**PETITION TO THE VILLAGE OF LIBERTYVILLE FOR
DEVELOPMENT APPROVAL**

THE UNDERSIGNED Petitioner, Pulte Home Company, LLC, a Michigan limited liability company (“**Petitioner**” or “**Pulte**”), as the contract purchaser of the property legally described on **Exhibit A** (“**Subject Property**”), respectfully petitions the Village of Libertyville (“**Village**”) to:

7. Petitioner seeks to acquire the Subject Property to demolish Libertyville Manor and redevelop the Subject Property with sixty-four (64) single-family homes and seventy (70) age-restricted duplex units.

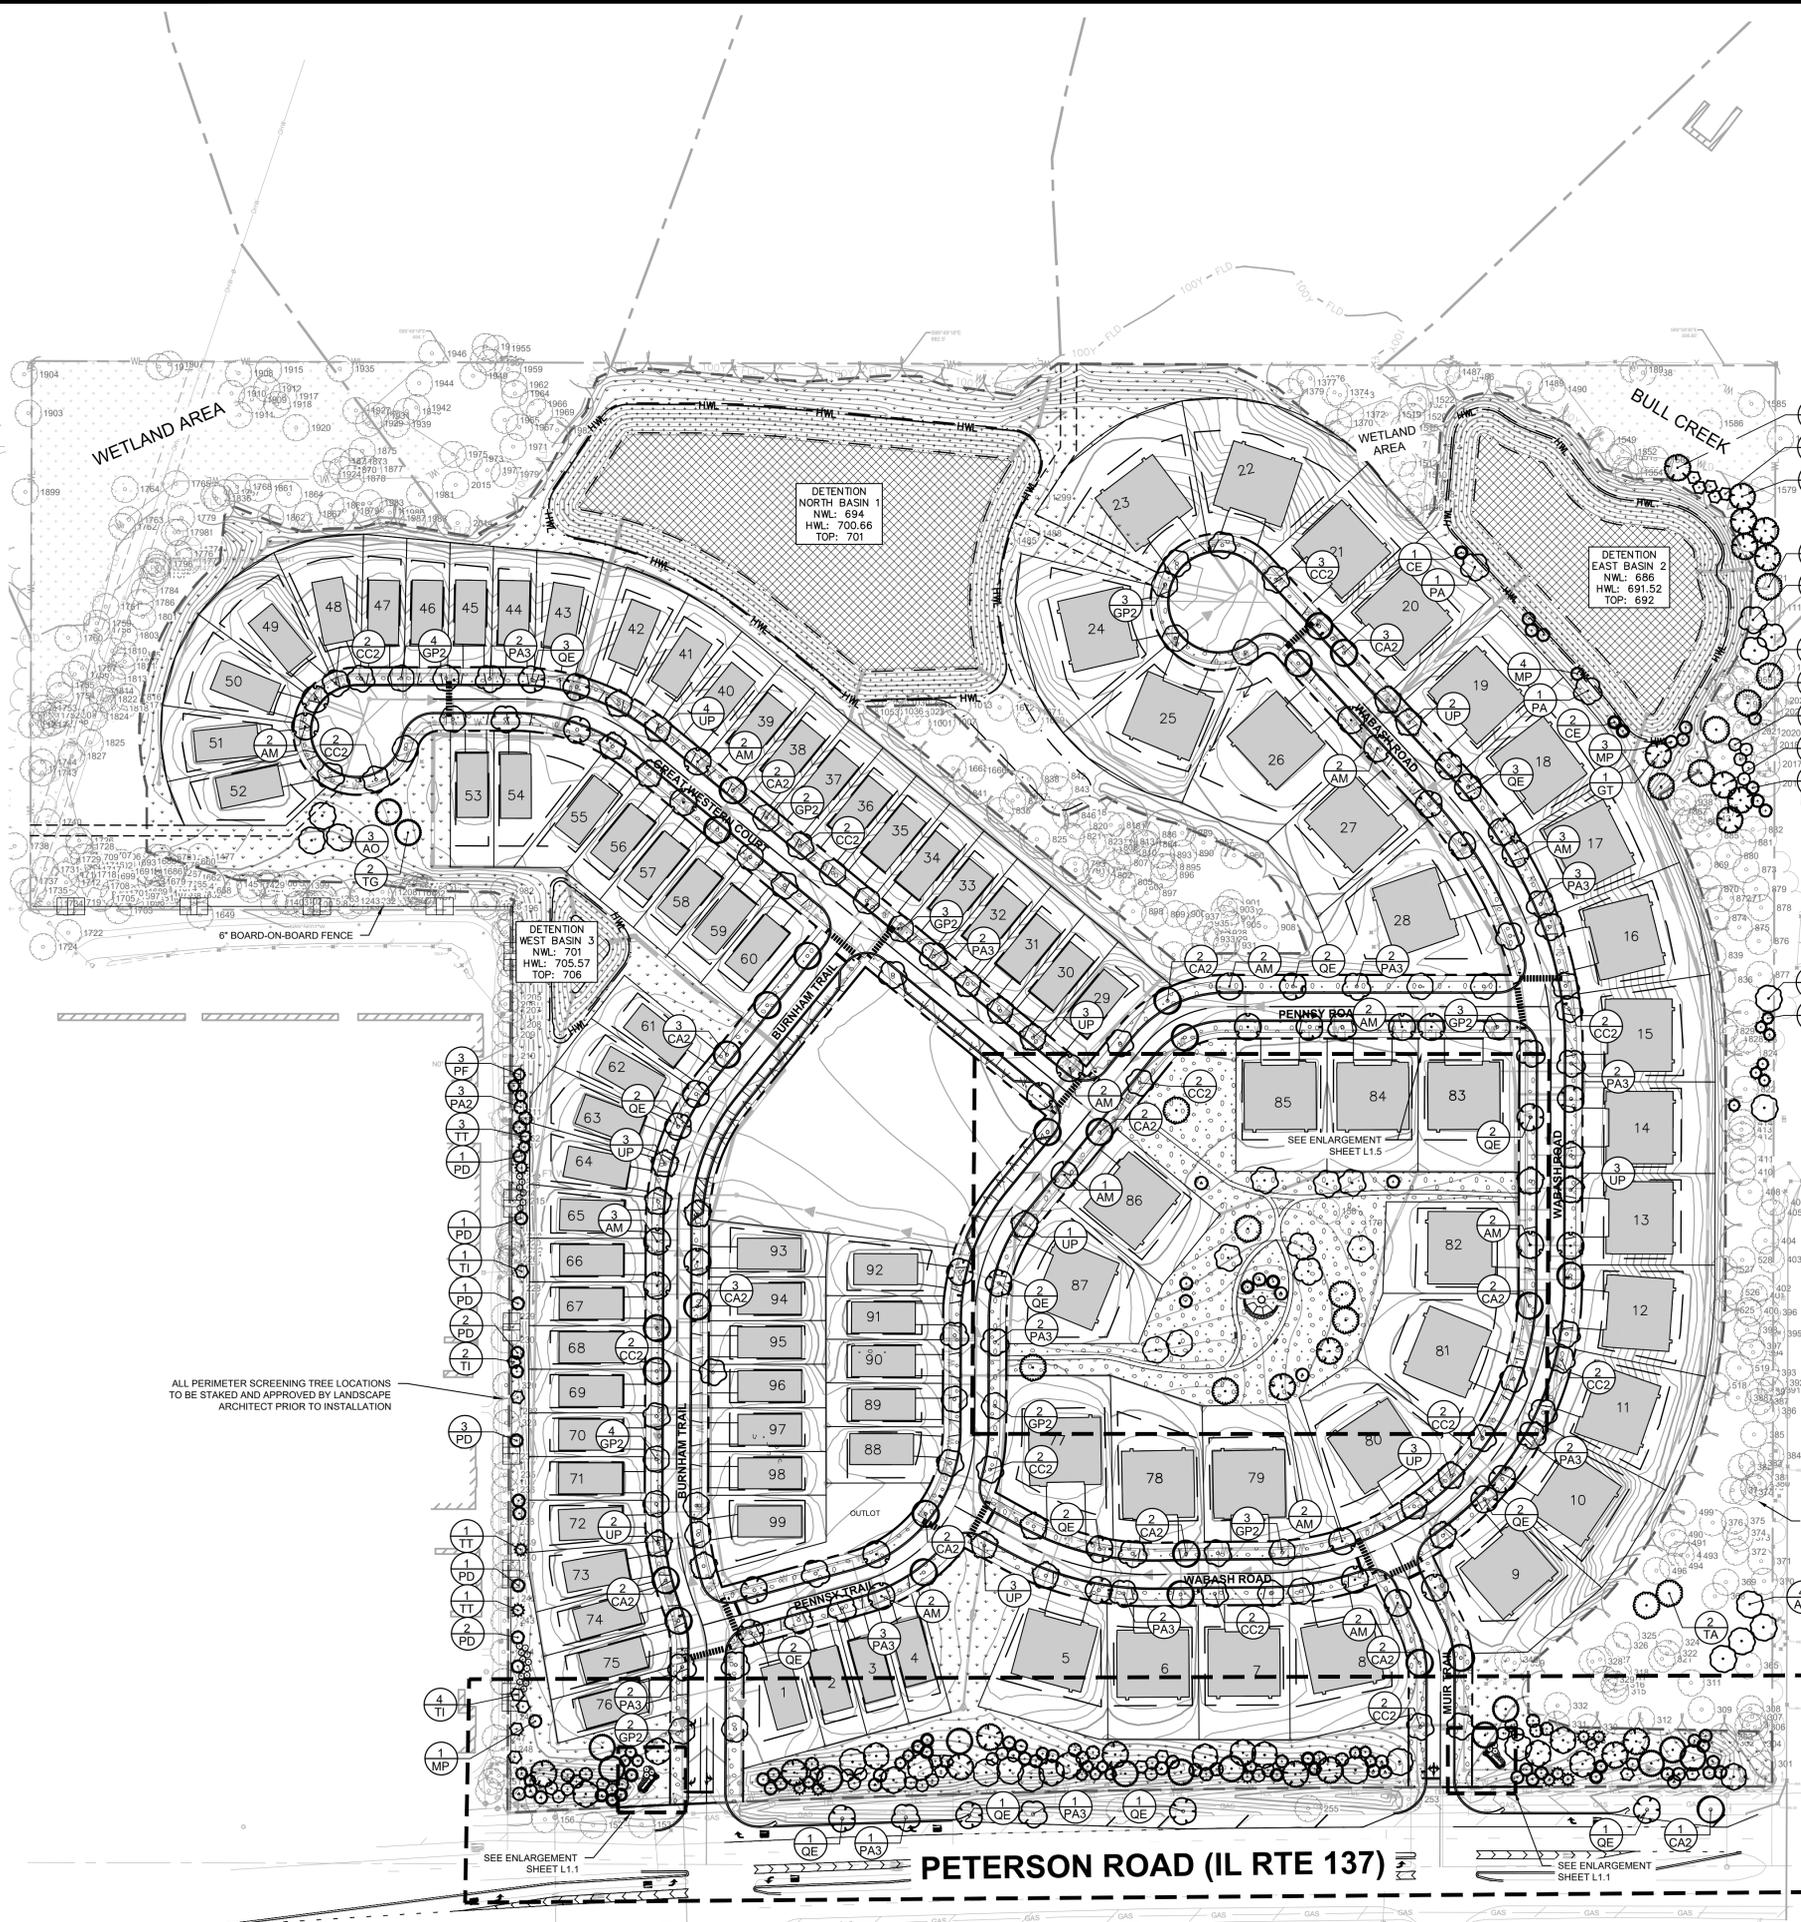
4. Sheet L1.0, Landscape Plan of the preliminary landscape plan, dated March 7, 2025, designed by Kimley Horn, shows a landscape buffer between Victoria Park and the subject development. Staff notes that the final quantities of trees are to be field verified to provide additional screening. While final quantities for the proposed landscape buffer have not yet been determined, they should not be less than what is currently shown. Consideration should be given to additional trees where possible and low ground shrubbery to fill any gaps within the landscape buffer.
